UNITED STATES PATENT AND TRADEMARK OFFICE

APPLICATION NO.	FILING DATE	FIRST NAMED INVENTOR	ATTORNEY DOCKET NO.	CONFIRMATION NO.
10/826,014	04/16/2004	Yasuhito Miyata	79874	9236

Office Action Summary	Application No. 10/826,014	Applicant(s) MIYATA, YASUHIITO	
	Examiner Eric Culbreth	Art Unit 3616

DETAILED ACTION

FIG. 3

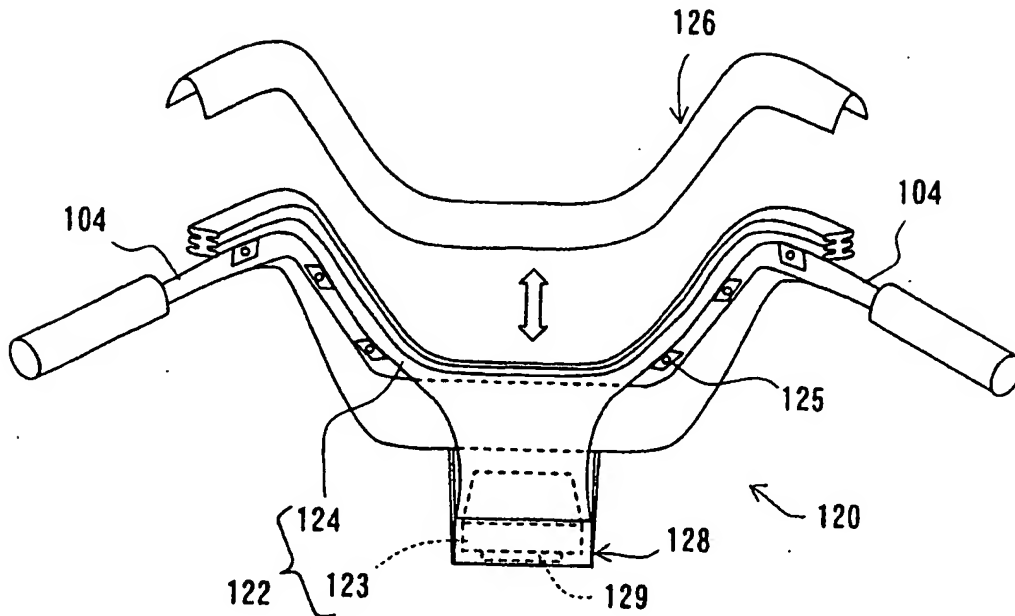
a. In Figure 3 and paragraphs [0018] and [0027], "A-A" should be "4-4", as a section line should be named for the figure it represents.

Not Approved
EC
9/7/04
